CITY OF PORTLAND, MAINE

Project Name:	The Schlotterbeck Block	Project ID:	2016-078
Address:	117 Preble Street	CBL:	033 E001 001 and 033 E005 005
Applicant:	Schlotterbeck Block, LLC		
Planner:	Shukria Wiar

PLANNING BOARD REPORT PORTLAND, MAINE

Subdivision and Site Plan Amendments
117 Preble Street
Level III Amendment to Subdivision and Site Plan
Project ID #2016-078
The Schlotterbeck Building, Applicant

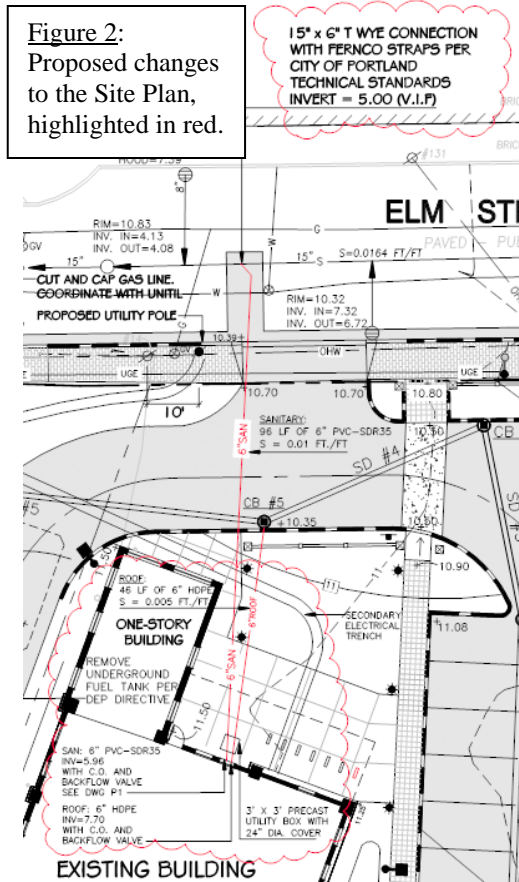
1. **Additional Bicycle Racks:** The additional unit eliminates the bicycle storage room in the basement. As a result, fourteen (14) bicycle parking spaces need to be located on the site. The attached revised L2.0 show an additional bicycle hitch under the canopy and six (6) exterior bicycle racks on a concrete pad located near the building entrance. With these revisions, thirteen (13) bicycle loops are provided and 26 bicycle parking spaces will be provided.

2. **6-inch Fire Water Line:** Attached revised L3.0 adds a new six-inch fire suppression water line from Preble Street to the building's fire suppression system. The applicant had planned to continue using the existing 6-inch fire suppression line, but the existing 6-inch line is in poor condition.

3. **Roof Drain Connection:** Attached revised L3.0 shows a new 6" HDPE roof drain connecting to catch basin #5. The existing roof drain pipe is in poor condition and needs to be replaced.

4. **Sanitary Sewer Line:** Excavation exploration revealed the existing 6-inch cast iron sanitary sewer line is in poor condition. The applicant proposes to replace the existing sewer line with a new PVC sewer in approximately the same location and wye connect the 15-inch combined sewer on Elm Street.

5. **Additional Sidewalk Ramp and Pedestrian Easement:** The City's staff has requested an additional sidewalk ramp at the intersection of Preble and Kennebec Streets, as part of the December 2015 conditions of approval. The new ramp will require pedestrian easement on the

applicant's lot. The attached Amended Subdivision Plan and sheet L2.0 show the new sidewalk ramp and the pedestrian easement.

1. The proposed new six-inch sanitary sewer connection to the sewer main in Elm Street shall be made with an INSERTA TEE connection (not a saddle Y attached with stainless steel bands). This detail shall be shown on the final plan.

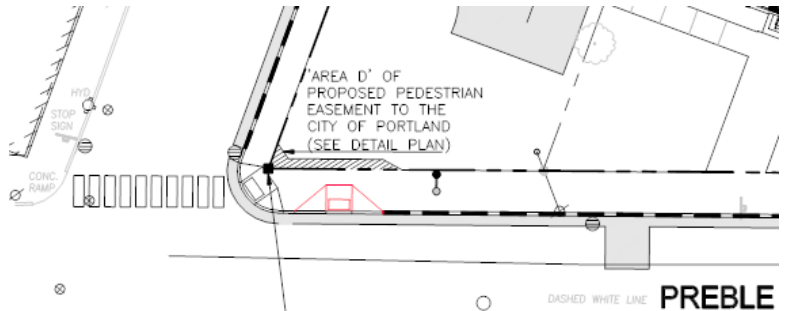
As part of the original approval, there was a condition in regard to the design of the handicapped ramp at the Kennebec Street intersection with Preble Street are needed. The ramp needs to be fully ADA complaint and upgrades of the ramp. The condition of approval is stated below:

The applicant has provided a detail for the sidewalk ramps at the corner of Preble Street and Kennebec Street. The general configuration is acceptable. Some adjustments are suggested for consideration including 7-foot tip-down curbs at the Preble Street ramps. The City generally prefers a minimum 4-foot separation between ramps. I need to coordinate with DPW on this detail. The plan seems to indicate a low curb reveal between ramps that doesn't meet City standards. I would suggest that a condition of approval be required that notes final ramp details to be provided for review and approval prior to construction.

The details for the design engineering of the ramps shall be further reviewed by City staff and any possible adjustment shall be coordinated with Department of Public Works and the Planning Division. The applicant shall also provide a detail for Sidewalk Ramp Detectable Warning Panels in accordance with Figure I-7 of the City of Portland Technical Manual.

Figure 3 – Revised Site Plan

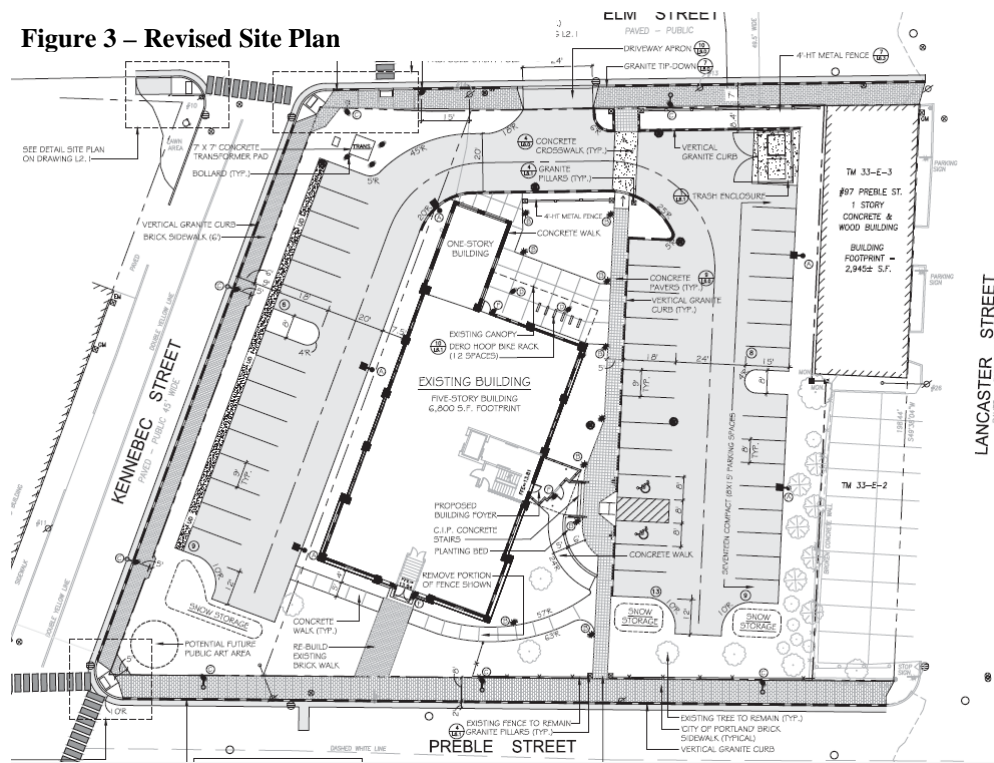
The main vehicle access is proposed from Elm Street via a new 24 foot wide drive. Surface parking lots surround the existing building and are proposed along Kennebec Street and Elm Street. Originally the applicant was proposing fifty-five (55) parking spaces. Based upon a revised parking demand analysis, the number is of parking spaces is forty-five (45). Twenty-four bicycle parking spaces proposed on the site. The parking areas are visible from the public

streets. The revised parking plan has eliminated the proposed care share for tenants. Please note the U-haul car share vehicles are available on Elm Street at the Public Library. Designated areas for snow storage are located adjacent to parking spaces.
